**BOARD OF APPEALS, CITY & COUNTY OF SAN FRANCISCO**

Appeal No. **26-042**

The substance or effect of the decision or order appealed from is the ISSUANCE on July 23, 2026 to Jinghui Wu, of an Alteration Permit (Revision to Permit No. 202603127448: new deck at rear (8 x 20ft) and minor layout changes) at 2463 Alemany Blvd.

**Appeal of Building Permit No. 202607145029**

SCALE: 1/4" = 1'-0"

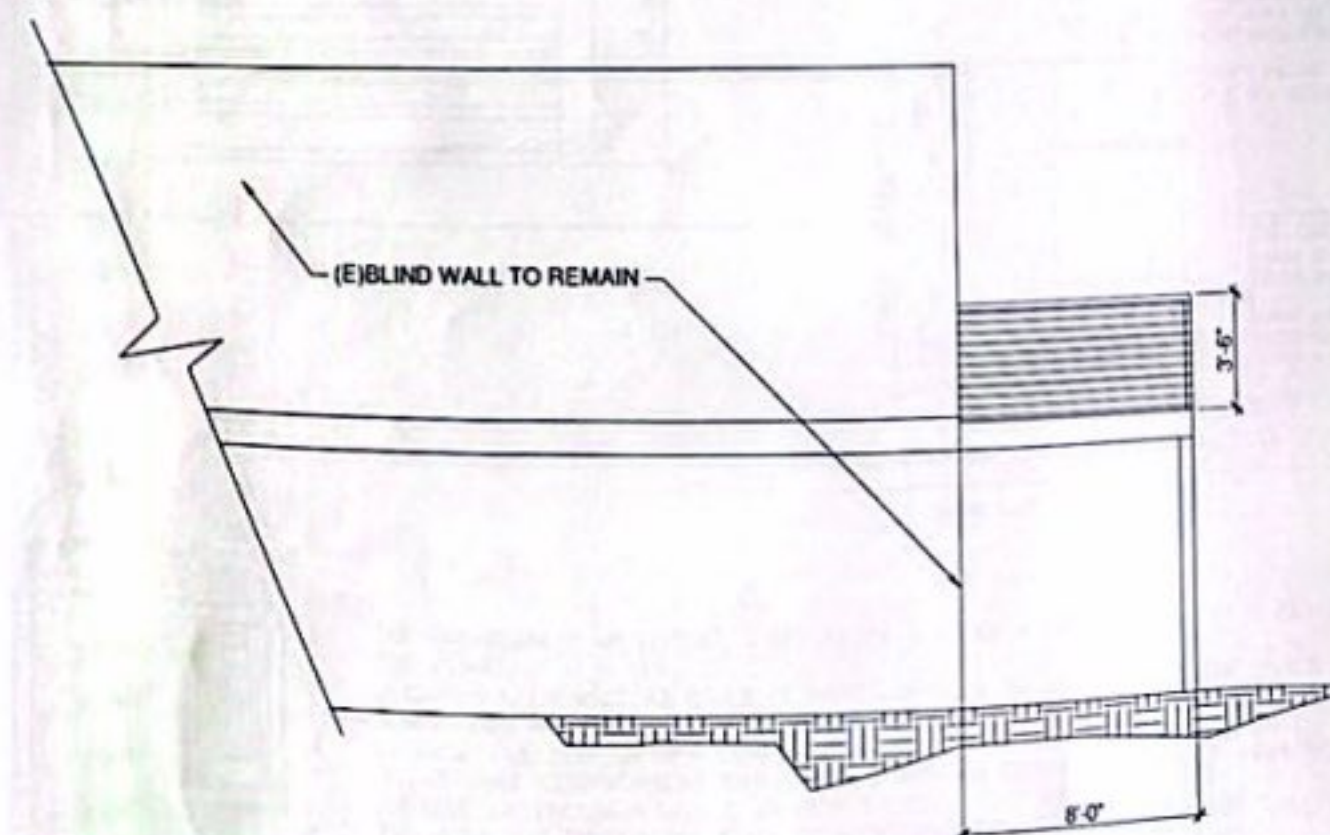
**1. Privacy Impacts** - Due to the height and placement of the proposed deck, occupants on the structure will have a direct line of sight into our primary bedroom, located at the rear of our home. The proposed deck would materially diminish our ability to enjoy our bedroom and the rear portion of our property without exposure to views from the neighboring deck.

**4. Neighborhood Aesthetic Impacts** - The proposed deck, measuring approximately 160 square feet, would be the largest rear-protruding structure on our block. Its size and elevation are inconsistent with the existing pattern of development and will negatively affect the visual character of the neighborhood. The structure will be prominently visible from multiple adjoining properties and will alter the established aesthetic of the rear yards along the block.

Red line is about 6 feet in between appellant's primary bedroom window and proposed deck

The Permit Holder respectfully requests that the Board deny the appeal and uphold Building Permit No. 202607145029 without modification. The permit authorizes a modest, approximately 8-foot-by-20-foot rear deck serving a single-family home. The deck is outside the Planning Code's required rear-yard area, does not exceed nine feet in projection, has a walking surface less than ten feet above grade, is set back three feet from the shared property line, and uses an open guardrail and open post-supported construction.

The Permit is consistent with the Planning Code and Residential Design Guidelines. While the Appellant raises concerns about privacy, the proposal does not create any unique or substantial privacy issues beyond what is expected for development within the City. More specifically, it follows the guidance provided by the Planning Department’s “Residential Decks” handout by providing the 3-foot setbacks at each side.
